MEMORANDUM

From:	Built Heritage Officer		
Service	Green Infrastructure	App No:	243127 + 243128
Address:	URS Building, Whiteknights Campus, Earley, RG6 6BW.		
Proposal:	243127: Full application for proposed external and internal refurbishment, repairs and alterations consisting of replacement windows and doors; replacement roofs, including new roof lights, cowls, and lanterns; installation of solar panels; concrete repairs; full mechanical and electrical services upgrade; erection of two external staircases; new detached bin and bike store; and hard and soft landscape and accessibility improvements. 243128: Listed Building consent for proposed external and internal refurbishment, repairs and alterations consisting of replacement windows and doors; replacement roofs, including new roof lights, cowls and lanterns; installation of solar panels; concrete repairs; full mechanical and electrical services upgrade; erection of two external staircases; new detached bin and bike store, and hard and soft landscape and accessibility improvements.

Heritage Asset:	URS Building – grade II listed building status since 2016. Whiteknights Park – Local Historic Park & Garden classification made by t

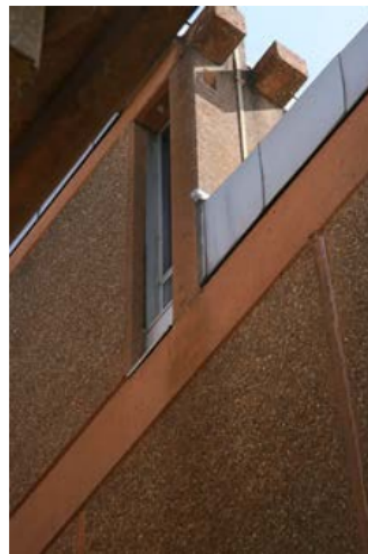
without further details being provided, which could be dealt with by means of a condition. The drawings for the windows do not seem to account for all the window forms of the building (attached below are photographs of various windows taken from the insufficient to understand what actual form and details for these elements, or the case of the windows as not all the variations in their design are not believed to be sufficiently detailed.

2360383-ACG-W033-ZZ-DR-A-42296 Rev.P

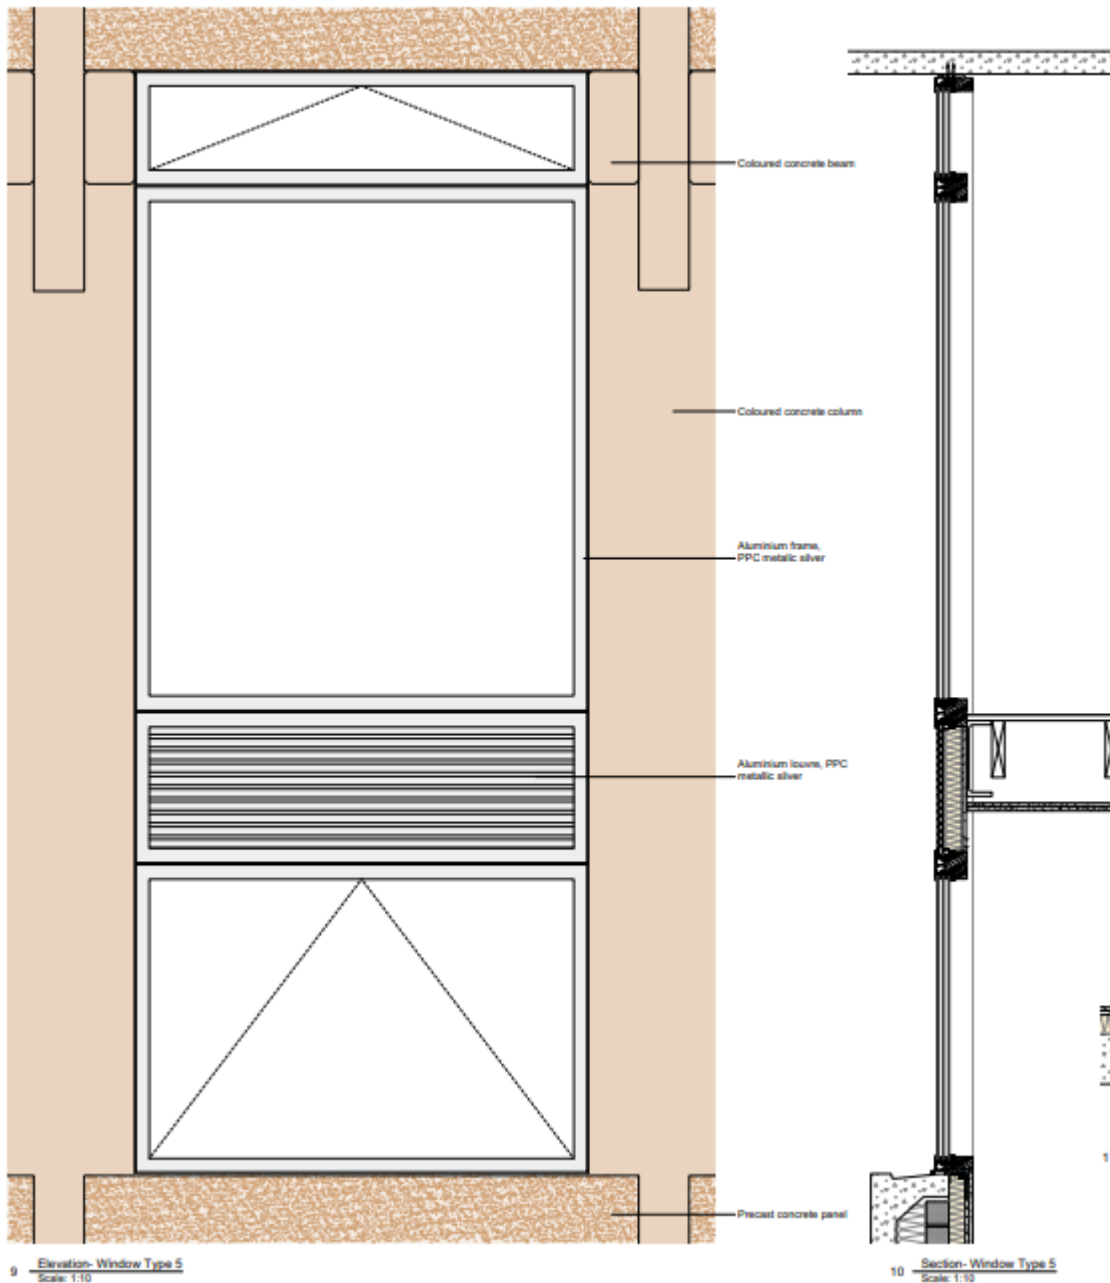
2360383-ACG-W033-ZZ-DR-A-42296 – here the cross-section drawing is stated to be Window Type 1, and the lower panel does not seem to relate to that shown elevation view.

2360383-ACG-W033-ZZ-DR-A-42296 Rev P this drawing does not make clear whether the solid panels of the window are to be new powder coated ones to match with the material and finish of frames.
